COUNCIL SUPPLEMENTARY ASSESSMENT REPORT – SOUTHERN REGIONAL PLANNING PANEL

Panel Reference	PPSSTH-111
DA Number	DA.10.2021.38793.1
LGA	Albury City
Proposed Development	Alterations and Additions to Albury Entertainment Centre
Street Address	525 Swift Street, Albury
Applicant	Habitat Planning (on behalf of Albury City)
Owner	Albury City
Date of DA lodgement	2 October 2021
Recommendation	Approval
List all documents submitted with this supplementary report for the Panel's consideration	<ul style="list-style-type: none"> • Attachment A: Habitat Letter (10 Aug 2022) • Attachment B: Architectural Plans, prepared by Peddle Thorp Architects (sheets A101-103) • Attachment C: Landscape Development Plan, prepared by T.C.L (26 July 2022) • Attachment D: Vehicle Turning Templates
Supplementary Report prepared by	Bioplan Pty Ltd
Supplementary Report date	8 September 2022

Figure 1: 400m and 600m radius from the AEC site, and associated publicly available off-street car parking (this does not show public on-street parking).

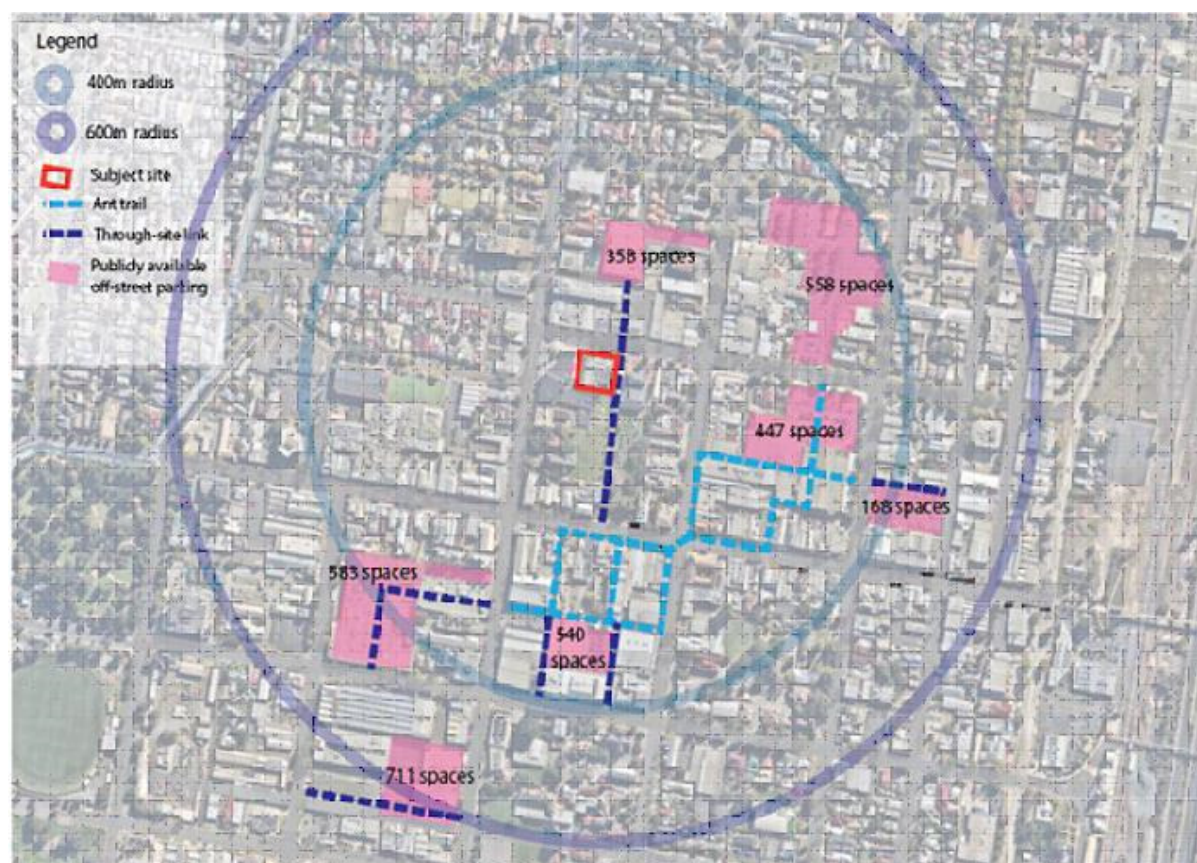
Within a 600m radius of the AEC, there are 3,365 publicly available off-street car parking spaces (Figure 1). The average occupancy of these combined off-street car parks is 66%. These spaces have varying time limits ranging from 1-Hour to All-Day. This does not include significant number of private off-street car parking within the CBD, nor does it include the additional on-street car parking available throughout the CBD, which ranges in time limits from 30 Minutes to All-day, and after 5:30pm is unlimited.
